## **Core Bus Corridor 9: Greenhills to City Centre**

16th December 2020

'Kissing Gate' access to Bancroft Park, Greenhills Road

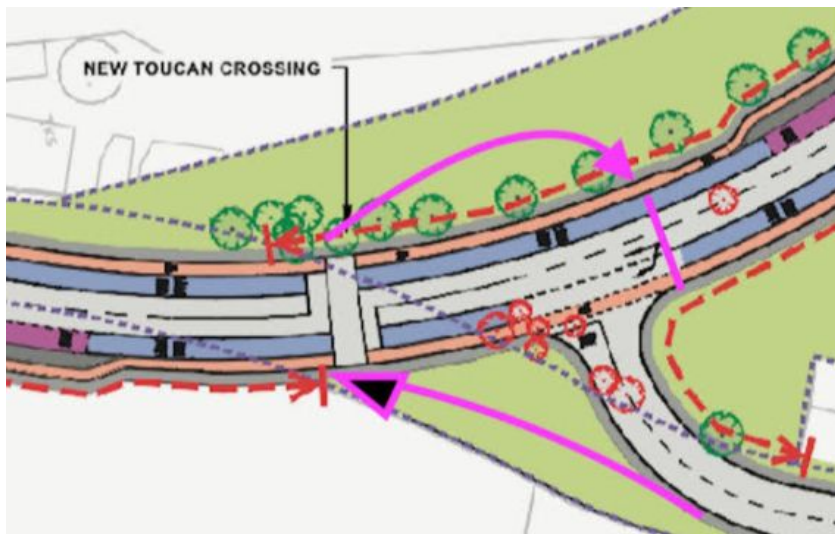
6. Access to the route from Bancroft Park is impeded by a “kissing gate”. This type of gate is difficult and time-consuming to negotiate for able bodied cyclists on standard bikes and impossible for cyclists on disability

bikes, trikes, bikes with children on board, cargo bikes, etc. and equally impossible for people on wheelchairs and those pushing buggies. Access to Bancroft Park could potentially provide access to Castletymon Road and on to Tymon Lane (Tymon Park) and CBC 7 (Tallaght) creating greater cycling links and network in the area.
